# EAST TOWN CROSSING FRONTAGE IMPROVEMENTS

## SEC. 26,35/ TWP. 20 N./ RGE. 4 E., W.M.

# EAST TOWN CROSSING PIONEER WAY IMPROVEMENTS

## R2.0

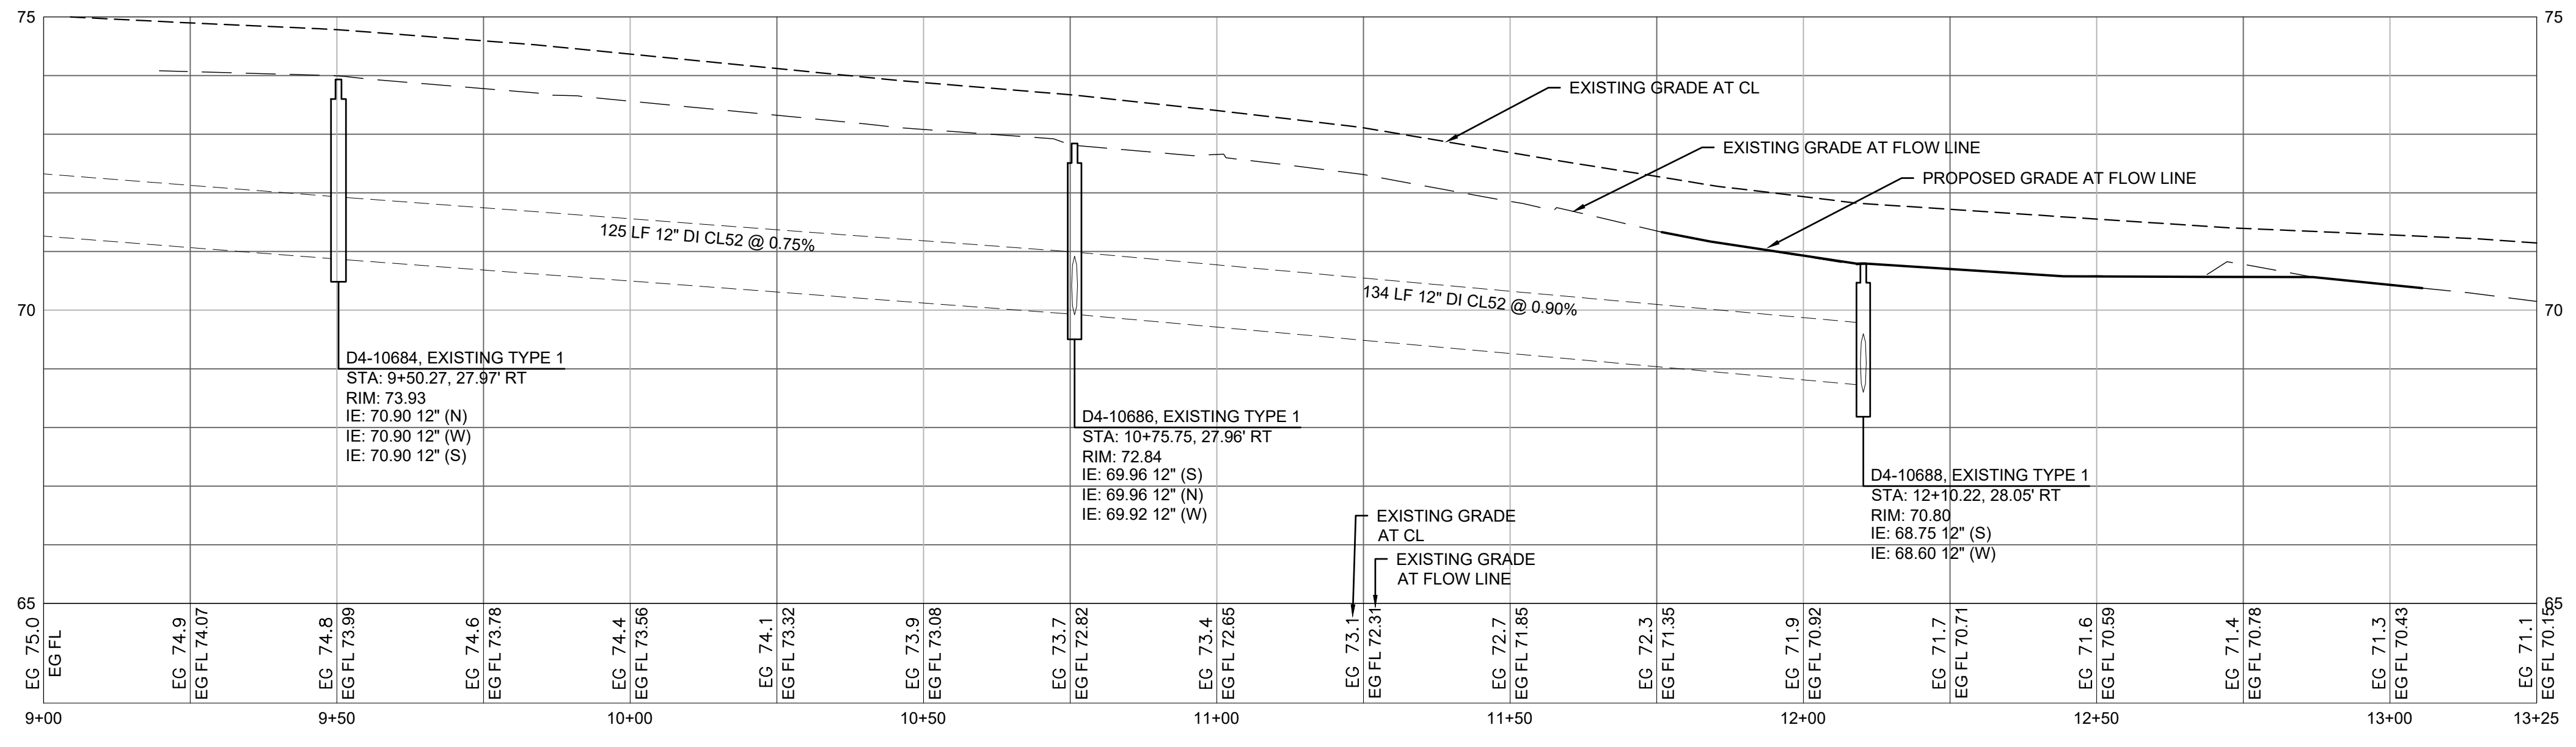
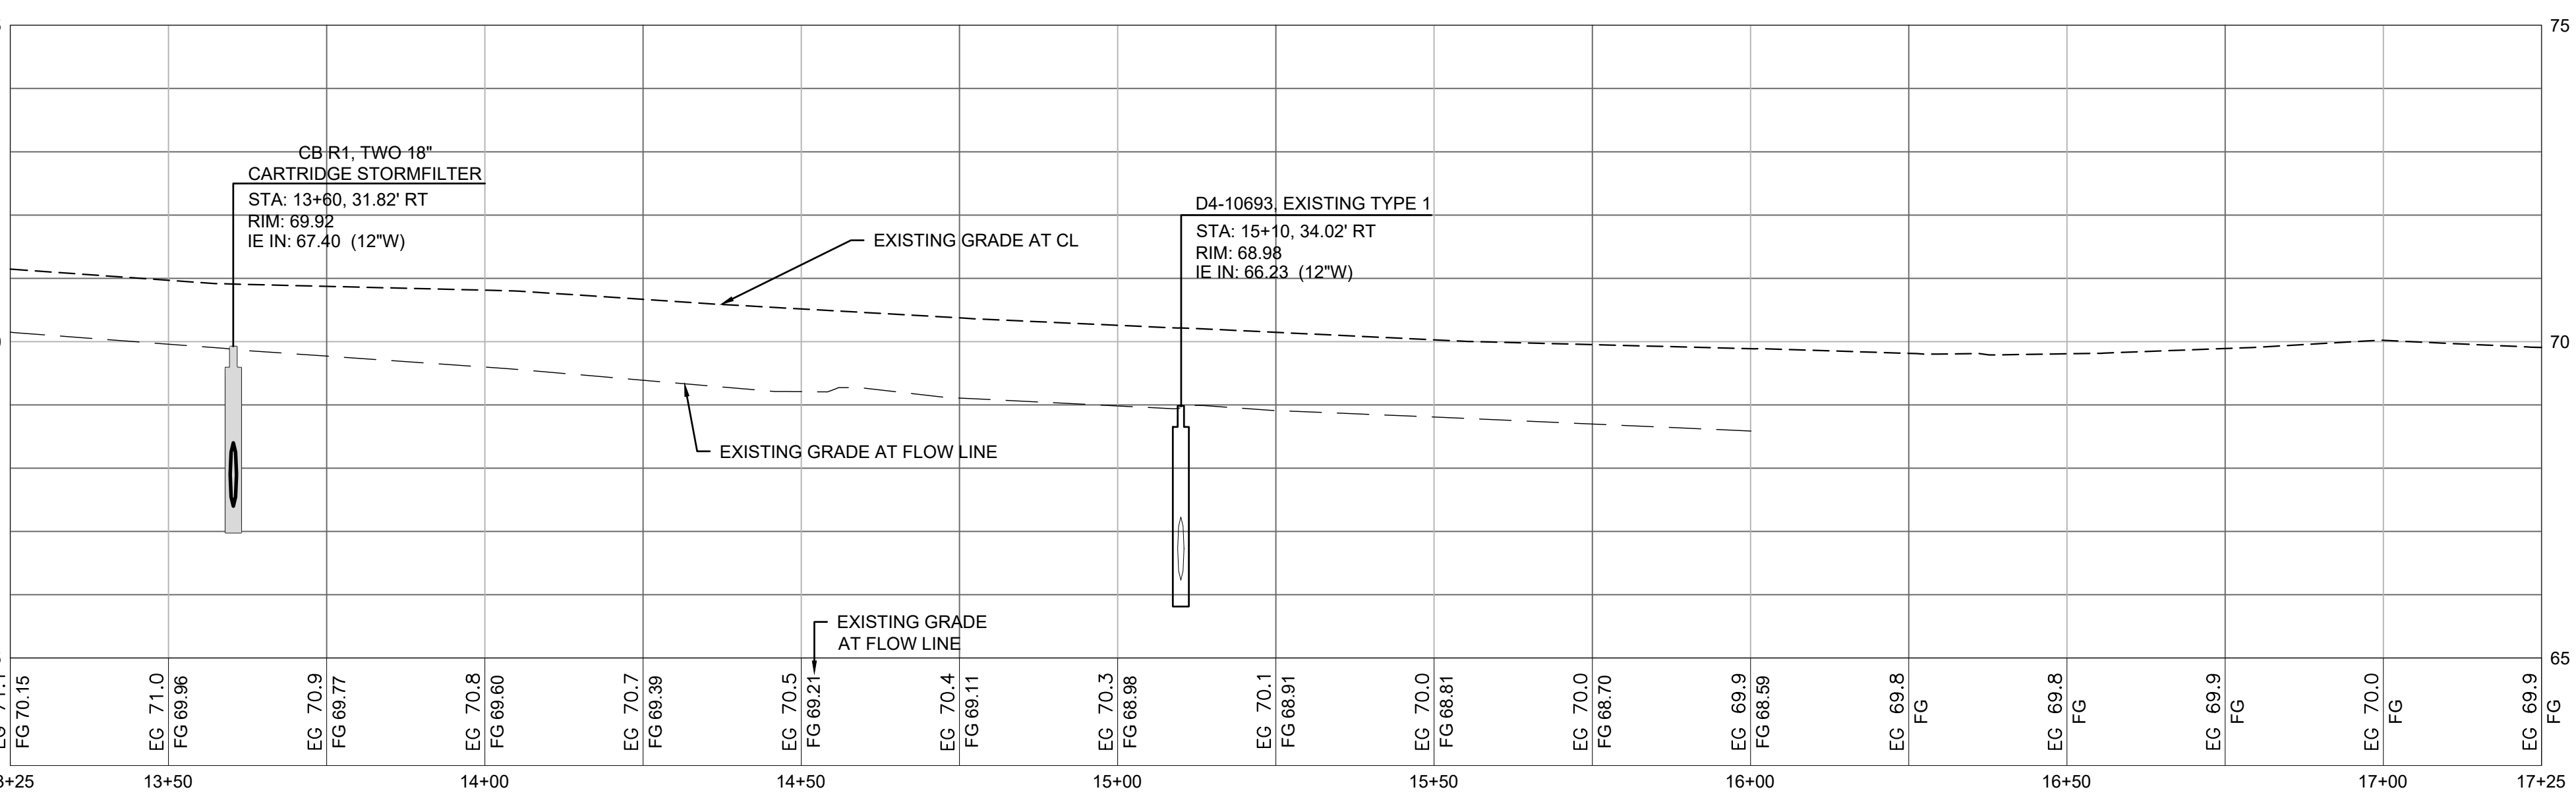
Verify-Sheet reference: [Plans: Sht R2.0 of 46] 12/16/2024

Per 2/11/25 meeting, leave the planter as-is (4.5ft planter with no 2ft gravel shoulder on west side of path). R2.0

updated to pm-04

2 ft gravel shoulder on west side removed.

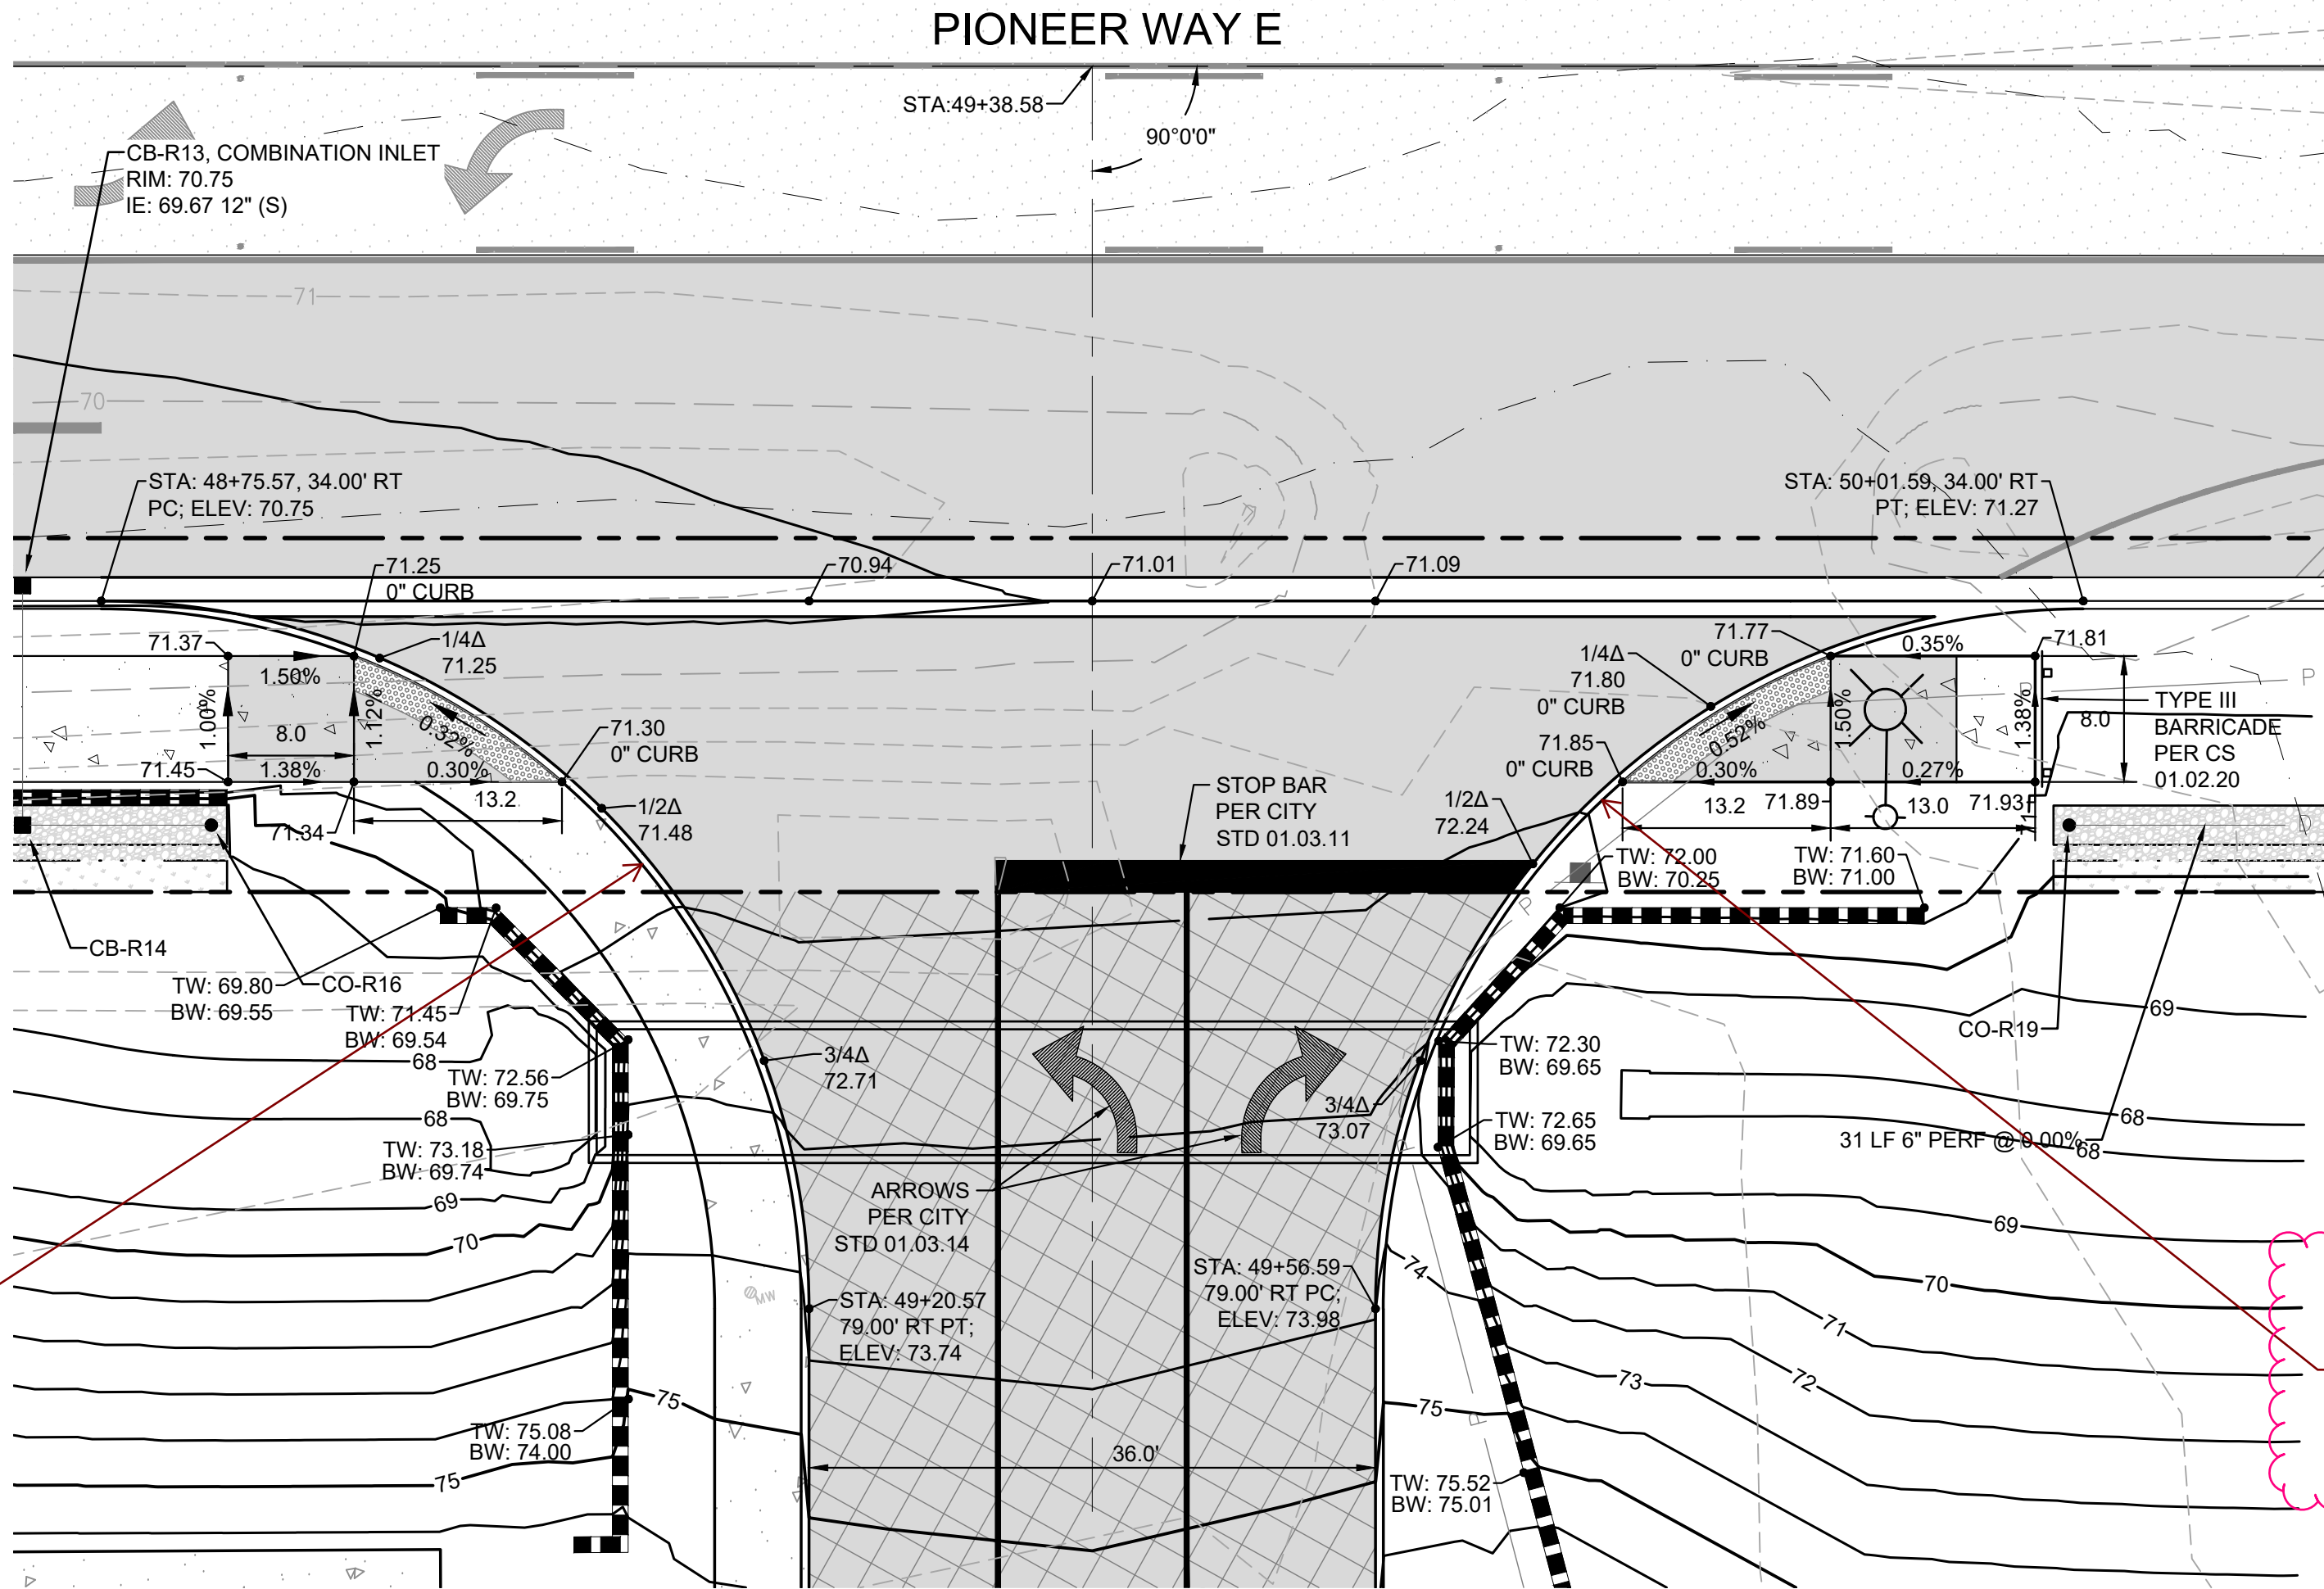
Curve info (delta/radius/length)?  
[Plans: Sh. R4.2 of 46]

Curve info (delta/radius/length)?  
[Plans: Sh. R4.2 of 46]

curve info added

curve info added
